CITY OF WESTMINSTER			
PLANNING APPLICATIONS SUB COMMITTEE	Date 26 June 2018	Classification For General Release	
Report of Director of Planning		Ward(s) involved Regent's Park	
Subject of Report	4 Wells Rise, London, NW8 7LH		
Proposal	Excavation of basement extension below part of existing building and part of rear garden with lightwell to front elevation and two rooflights and staircase from basement to garden level to rear. Erection of rear extensions at ground and first floor level, formation of roof terrace at rear first floor level, alterations to fenestration to rear including formation of Juliet balconies, and associated external alterations including to front forecourt and at roof level.		
Agent	Amos Goldreich Architecture		
On behalf of	Mr Ash Sahni		
Registered Number	18/02033/FULL	Date amended/ completed	12 March 2018
Date Application Received	12 March 2018		
Historic Building Grade	Unlisted

2. SUMMARY

Existing rear elevation (top) and proposed rear elevation (bottom)

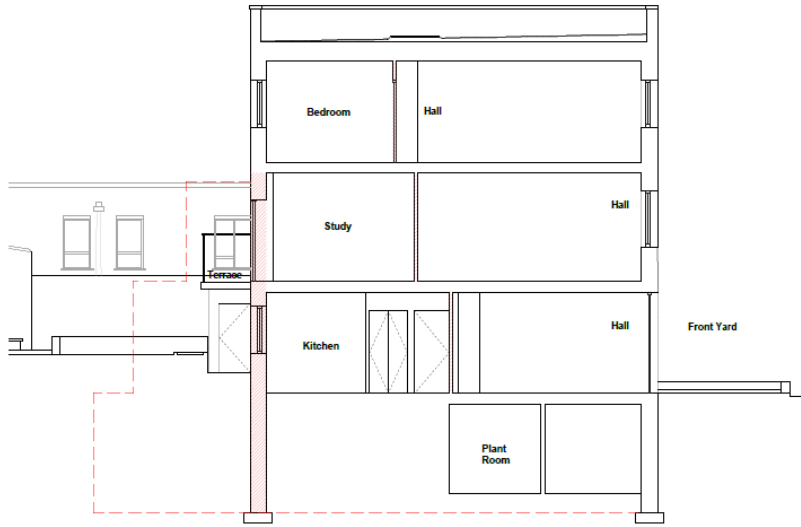
- Alterations to rear fenestration will harm the consistency of fenestration along the terrace.
- Architecture of proposed in terms of the size of the windows would be unsympathetic to this art deco house and inconsistent with other properties in the same terrace.

- Balcony is currently set away from boundary wall.
- Height of rear extension at first floor should be reduced to reduce sense of enclosure.
- First floor extension would increase enclosure to neighbouring garden.
- Noise disturbance from Juliet balconies to upper floors.

- Loss of privacy for neighbouring occupiers.
- Depth of first floor extension has not been reduced and therefore increased sense of enclosure and loss of light to neighbouring garden remains.
- Lift within extended building will cause noise and vibration.

The St. John's Wood Society and neighbouring residents have raised concerns regarding the detailed design of the replacement fenestration on the rear elevation. Whilst it is acknowledged that there is a relatively consistent approach to the fenestration on the upper levels of buildings in this the terrace, the proposed windows and doors are not considered to be unacceptable in this instance. The rear of the building is not appreciated in views from the public realm and would only be obliquely seen in private closer private views. Furthermore, as the building is not listed, there is a limited degree of control over the fenestration details and it is a material consideration in this case that as the building is in use as a dwellinghouse, the applicant could replace the windows, including amending the size, dimension and location of the windows and introduce Juliet balconies, without the need for planning permission. In this context, and as the proposed windows and doors would be metal framed, acknowledging the traditional material for art deco style buildings, it is considered that the alterations to the building's fenestration are acceptable in design terms and the objections raised cannot reasonably be supported as a ground on which to withhold permission in this case.

Whilst the proposed first floor extension would increase the height of the building at the boundary with the rear garden of No.6 Wells Rise, its projection from the existing building, against which it would be seen in views from the neighbouring garden, would be limited (1.64m) and as such, it would not result in a material increase in daylight or sunlight to this neighbouring garden.

The proposed first floor extension would be visible from the rear garden of No.6 Wells Rise. However, as set out in Section 8.3.1, given the small scale of the proposed extension and as it would be seen in the context of the bulk of the existing building, it is not considered that it would increase the degree of enclosure to the rear garden of No.6 Wells Rise to such an extent so as to warrant withholding permission.

Existing Section (top) and Proposed Section (bottom).

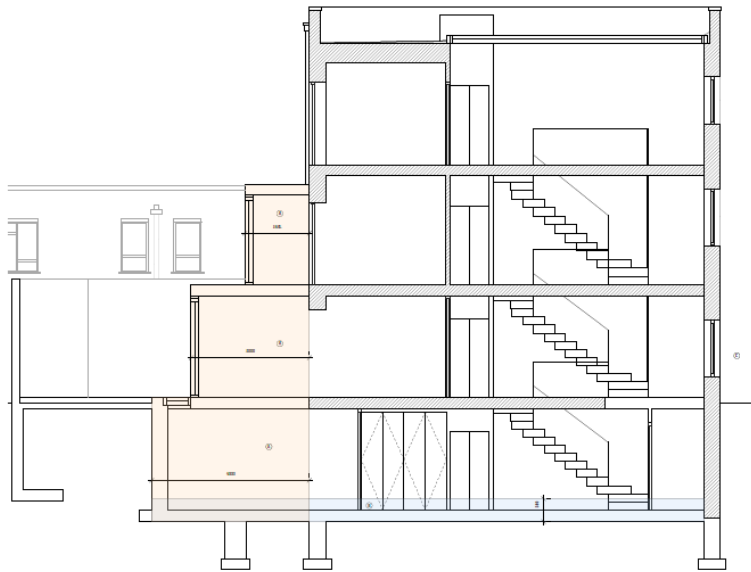
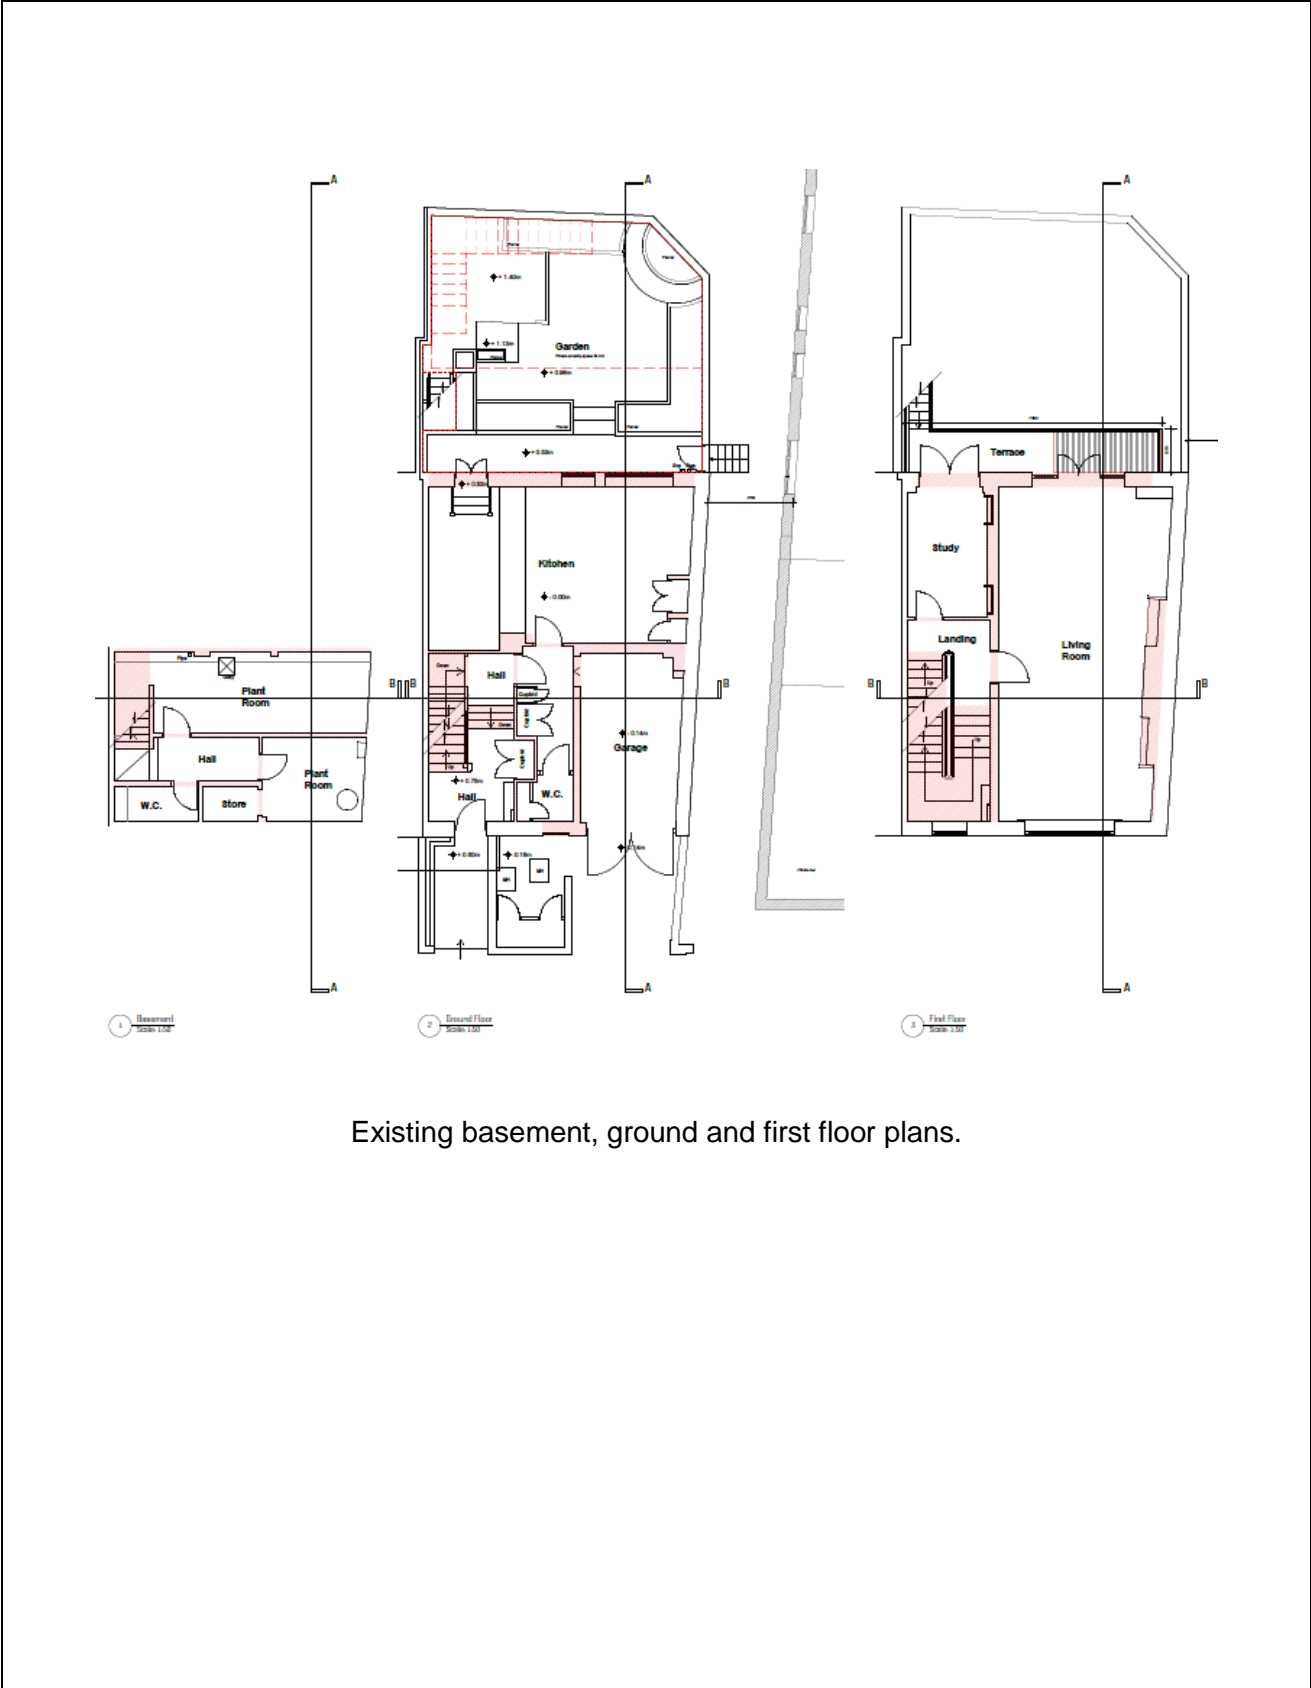
No objection, but note that details submitted don't include construction sequence for 'concrete beam'. Informative suggested to draw this to the structural engineer's attention.

- Adverse structural impact on the terrace.
- Design of underpinning to the party wall with No.6 should be reviewed.
- Houses of this period are more brittle and liable to crack.
- Building was war damaged and rebuilt in the 1950s.
- Houses have had flooding and water ingress to their basements caused by the new development at the corner of Wells Rise and St. Edmunds Terrace.
- Further details of structural works should be provided.

In respect of Part A of the Basement Development policy, the applicant has provided a structural engineer's report prepared by a qualified engineer explaining the likely methodology of excavation and the expected impact on adjacent properties. Concerns have been expressed by neighbouring residents in respect of the level of detail provided in the structural report and effect the methodology proposed may have on neighbouring properties. The submitted structural method statement has been assessed by Building Control and following provision of additional structural information on the method of construction of the proposed basement during the course of the application, they are content that the structural methodology proposed is acceptable, having regard to the ground conditions found in this part of the City.

It is important note that at planning application stage the purpose of the structural method statement is to demonstrate that a subterranean development can be constructed on the site having regard to the site, existing structural conditions and geology. It does not prescribe the engineering techniques that must be used during construction which may need to be altered once the excavation has occurred. The structural integrity of the development during the construction is not controlled through the planning system but through Building Regulations and the Party Wall Act. In this context, and given that Building Control do not object to the proposal, it is not considered that the objections raised on structural grounds can be reasonably sustained a ground on which to withhold permission.
